PERMIT MODIFICATION APPROVAL

Re: Permit Modification Approval for API Number 8510033 , Well #: PENS 1 HHS extended lateral

Permit Modification Request – Wells PENS1FHS/PENS1GHS /PENS1HHS

DRILLING WELL PLAN PENS-1H-HS Macellus Shale Horizontal

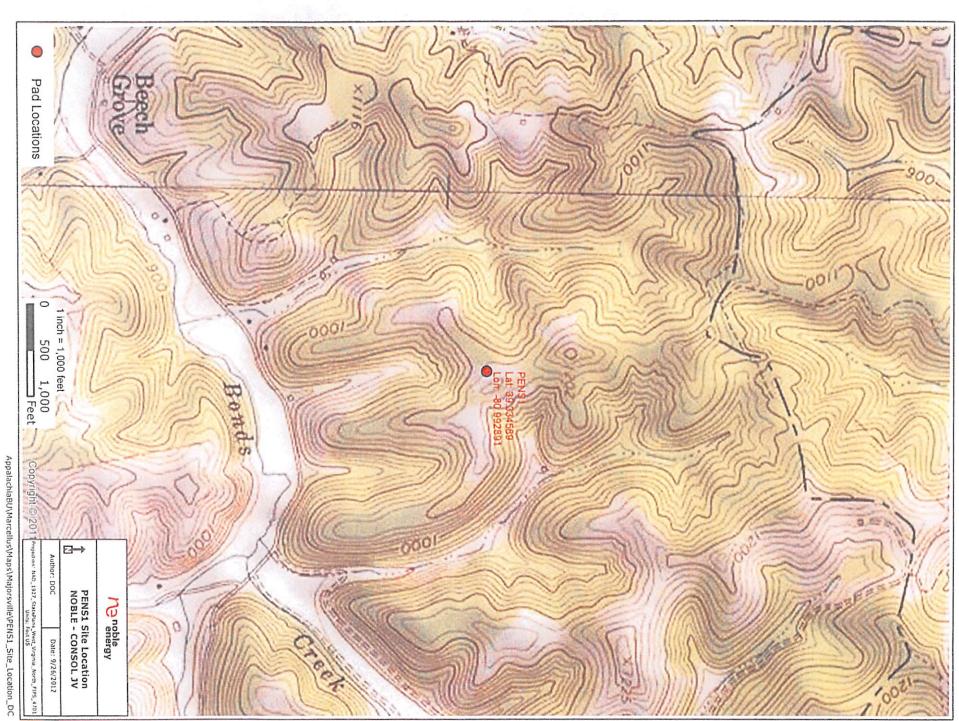
Enclosed are permit modification requests to extend laterals on the above referenced wells. Please let me know of any deficiencies and we will provide the information you have requested.

Noble Energy, Inc. requests to run surface casing to 650' so that our casing point will be in competent rock.
